MEMORANDUM

TO: City Planning Commission, Committee of the Whole
FROM: Aaron Hanauer, Senior City Planner, (612) 673-2494
DATE: March 17, 2016
SUBJECT: Westminster Presbyterian Church Addition Project
1200-1226 Marquette Avenue and 1221 Nicollet Mall

Committee of the Whole Submittal

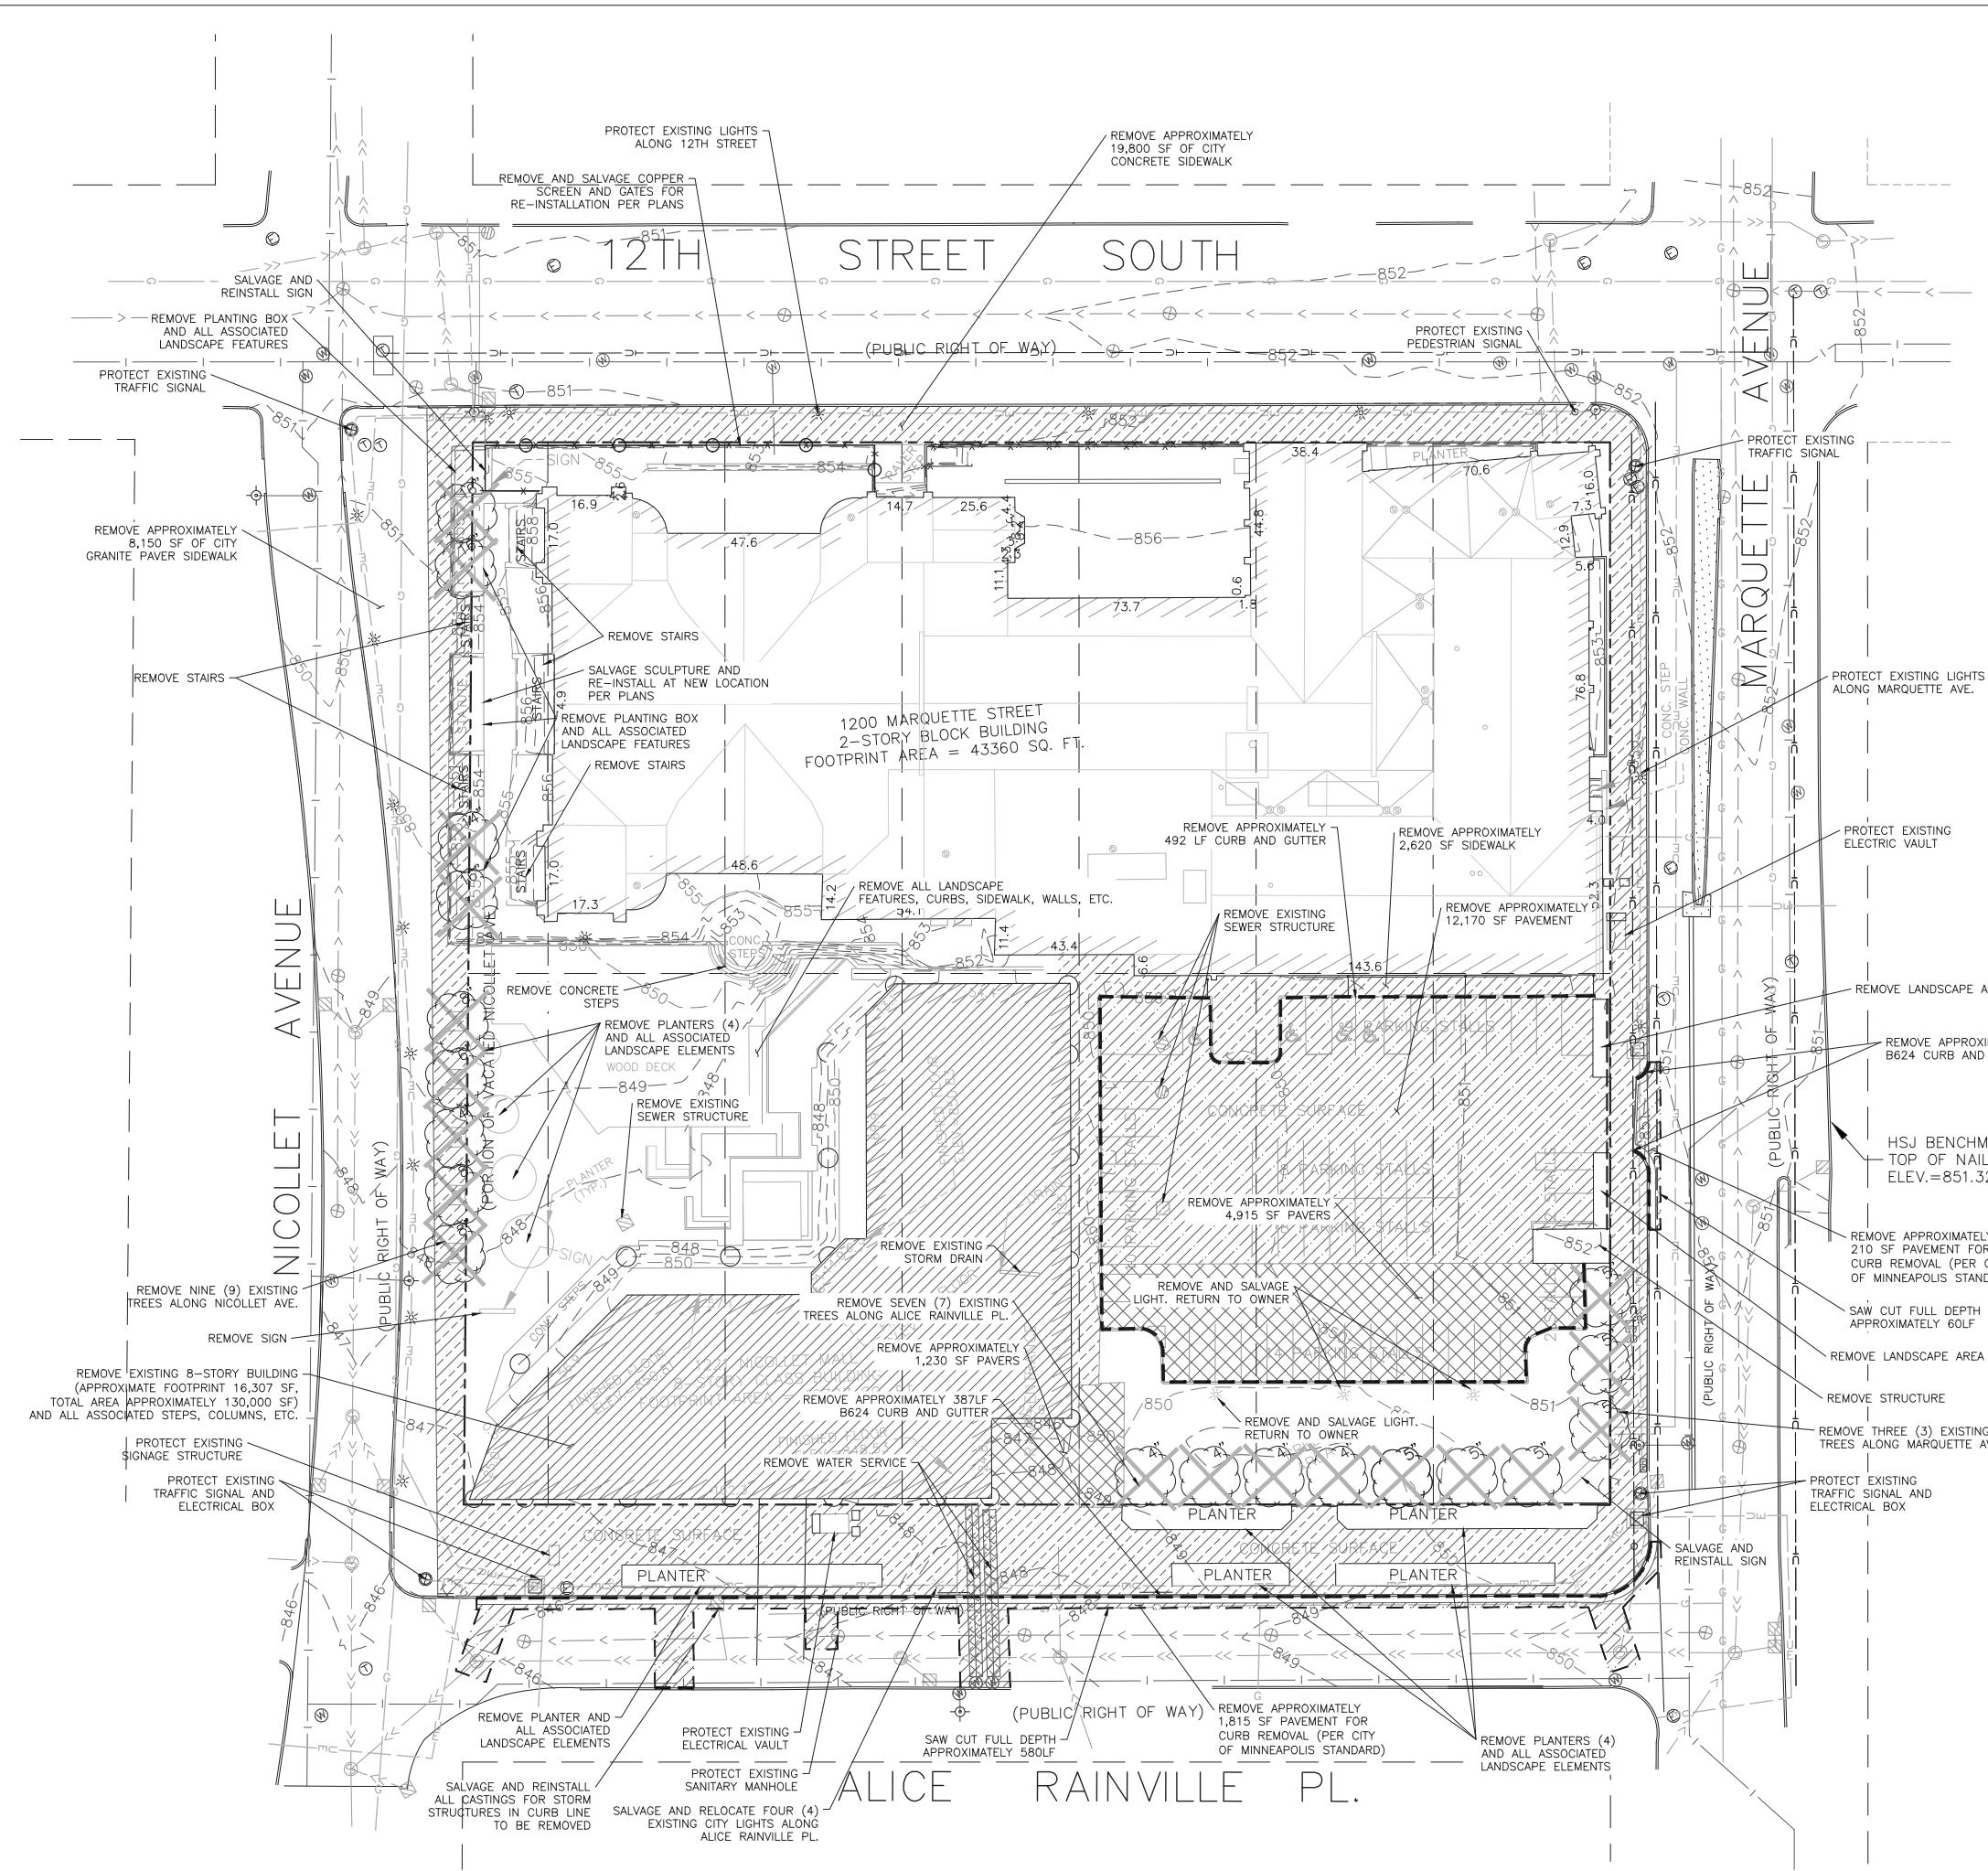
- Building placement. Site plan review requires that the first floor of buildings shall be located not more than eight (8) feet from the front lot line. In the case of a corner lot, the building wall abutting each street shall be located not more than eight (8) feet from the lot line. In addition, the placement of buildings shall reinforce the street wall, maximize natural surveillance and visibility, and facilitate pedestrian access and circulation. The building is setback 82 feet from Nicollet Mall and 98 feet from Marquette Avenue.

1. Building Placement

Per 530.110, the first floor of buildings shall be located not more than 8' from the lot line.

See the attached site plan (sheet C4.0) for setback dimensions to the property lines, which are more than eight feet. The proposed siting of the building addition respects the historic church facades, provides space to meet vehicular drop-off demands on site, affords the creation of plaza and landscape amenities, and mitigates challenges of the existing first floor level of the church being located well above grade.

- The greater setback from Nicollet Mall both respects the historic significance of the original church building and restores the original urban design intent of the building by exposing the historic south façade, which has been largely obstructed for over thirty years by an adjacent building.

- The greater setback from Marquette allows for a drop off drive to accommodate school buses, coach busses and general vehicular drop off on-site without the need for surface parking. This setback also provides space for possible future church expansion as the parking structure below is designed to accommodate up to a four story building.

- The greater setback distances allow for the creation of two public plazas having lush landscape plantings, trees, water features, art, decorative pavers, seating and a variety of stormwater BMP's. The Nicollet plaza addresses Nicollet Mall, the Loring Greenway and the new Loring Woods to help create a consequential southern node to the Nicollet Mile, and both plazas together provide for an open and welcoming streetscape along Alice Rainville Place.

- The greater setbacks allow for a gradual transition between grade and the existing first floor of the church which is between six and eight feet above grade. Bridging this distance within the plazas allows stairs and accessible ramps to provide well-designed transitions for pedestrians while also avoiding tall blank walls that would result on street frontages if these transitions were interior to the building.

1 EXTERIOR ELEVATION - WEST
A2.0 SCALE: 1/8" = 1'-0"

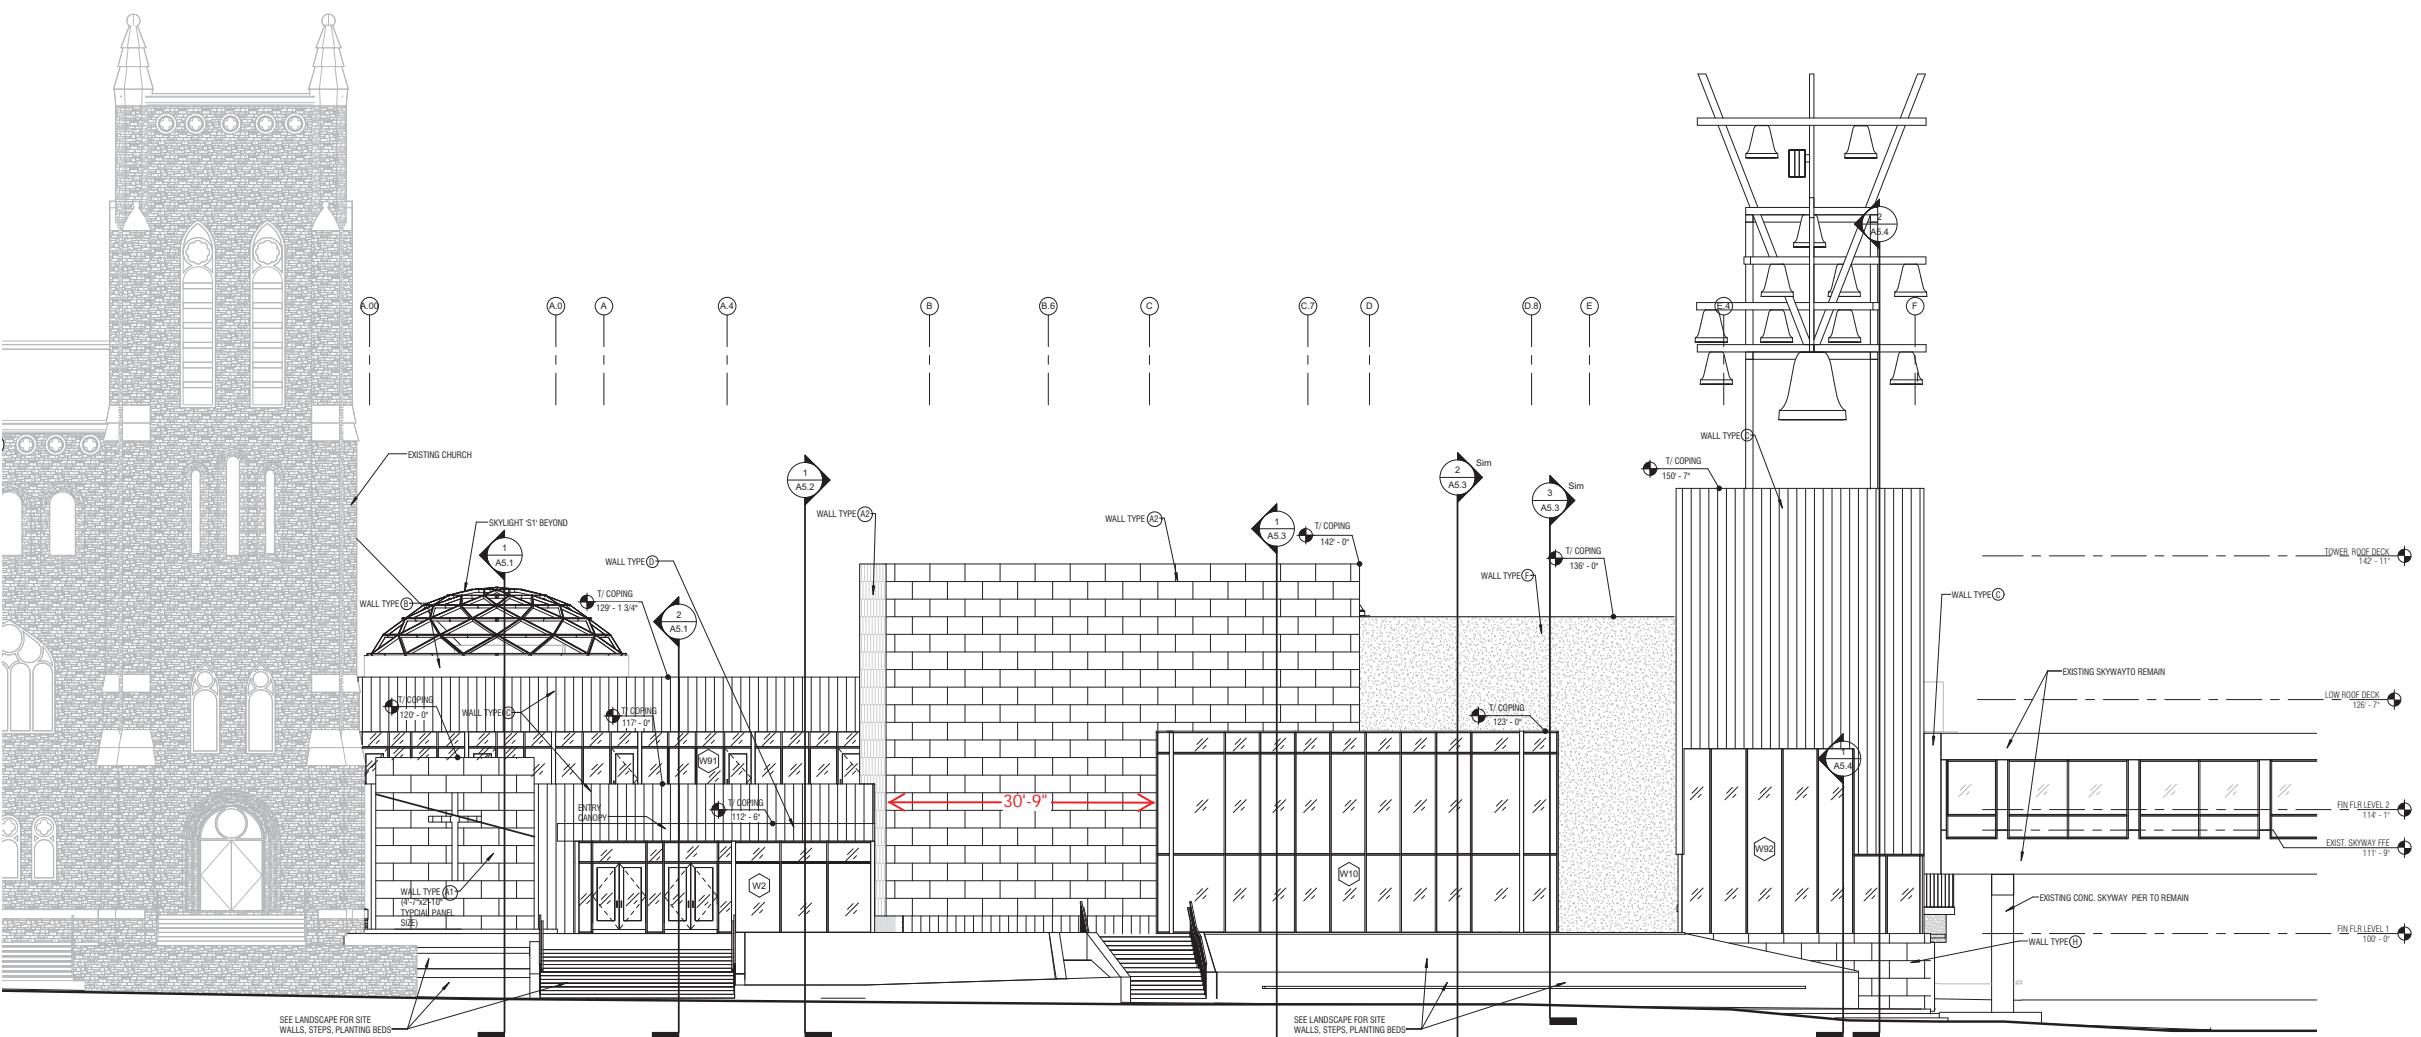
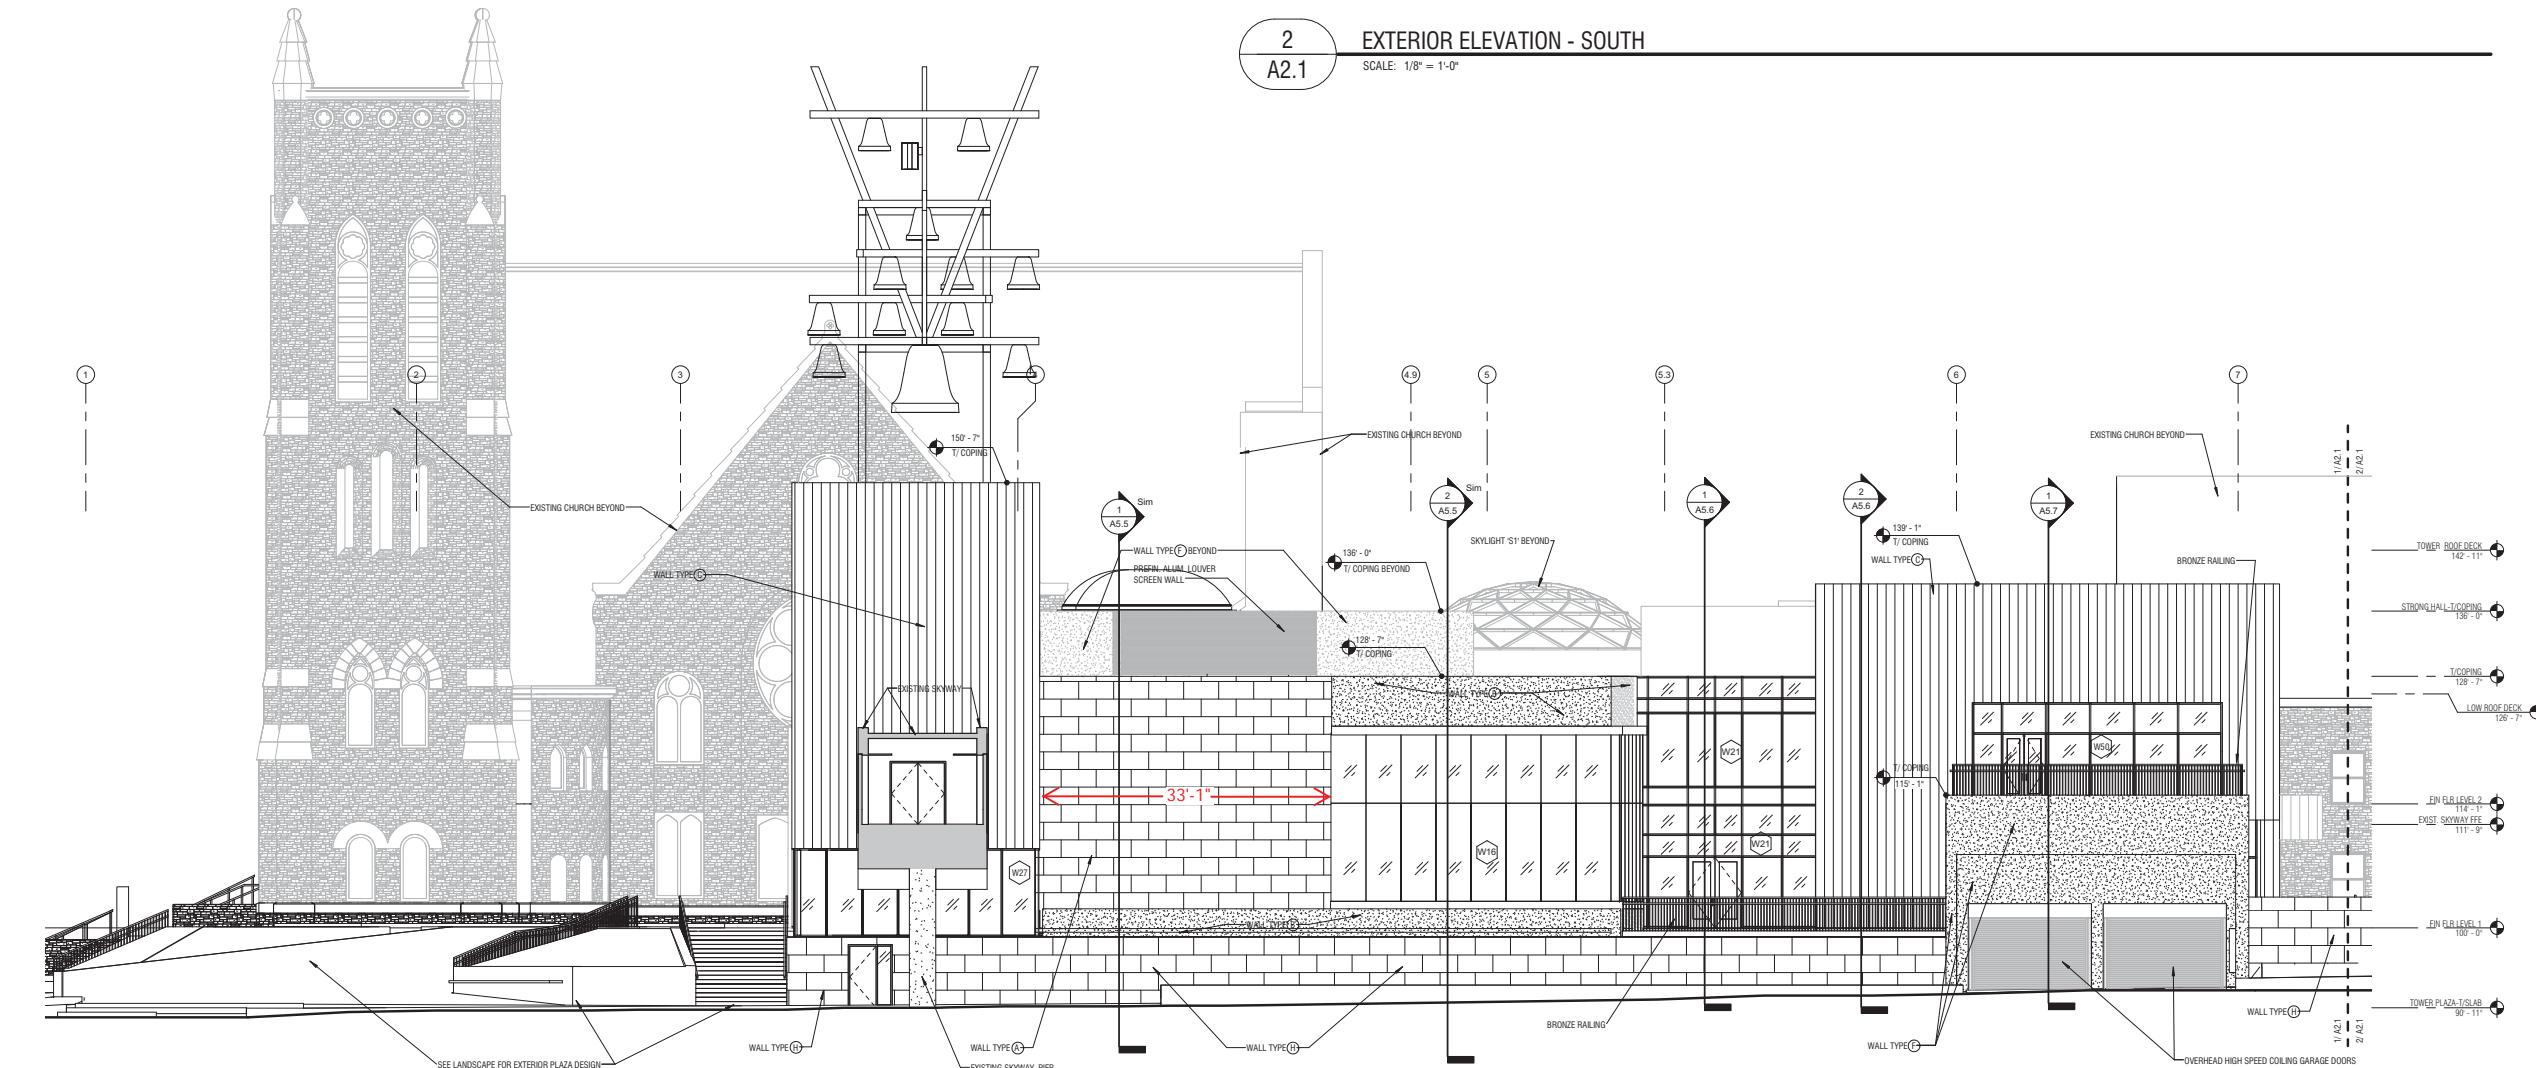
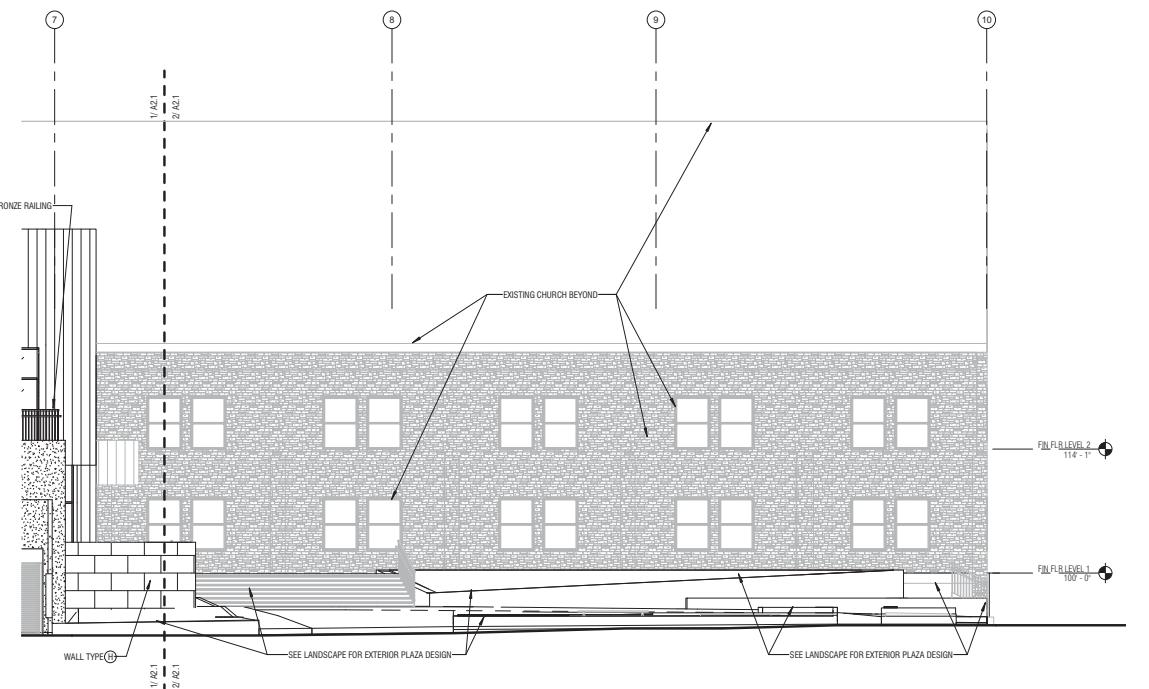
- Proposed blank walls. Site plan review requires that blank, uninterrupted walls that do not include windows, entries, recesses or projections, or other architectural elements, shall not exceed twenty-five (25) feet in length. The applicant notes on their elevation sheets (A2.0-A2.2) the three places where they have identified blank walls exceeding 25 feet. In addition, to these blank walls, the exposed parking garage along Alice Rainville Place is 128 feet long and ranges in height from 7 to 9 feet in height. The applicant is proposing a large landscape bed along this building wall. However, the elevation will have a lack of functions along an important pedestrian connection and within a proposed activity center.

2. Blank Walls

Per 530.120, the building shall not have blank, uninterrupted walls that do not include windows, entries, recesses, or other architectural elements that exceed twenty-five feet.

As illustrated in the attached elevations, there are blank walls exceeding twenty-five feet on three facades. It is proposed that the 30'-9" blank wall facing Nicollet, the 33'-1" blank wall facing Alice Rainville, and the 31'-7" blank wall facing Marquette be permitted.

- The room behind the blank wall facing Nicollet is a large assembly space accommodating over 300 people for theatrical performances and worship. A large glass wall is provided into this room on this façade, however additional openings would prohibitively limit the uses of the space.

- The lower stone wall along Alice Rainville is the outside wall of the underground parking garage and not appropriate for windows (the first floor level of the existing church, being matched by the addition, is 6-8 feet above grade). The upper 33'-1" blank wall is left blank for a commissioned piece of artwork.

- The space behind the blank wall facing Marquette is the parking garage entry, which is not appropriate for windows. As shown on renderings, coniferous trees will be planted in front of this wall to provide visual interest and largely conceal this blank wall.
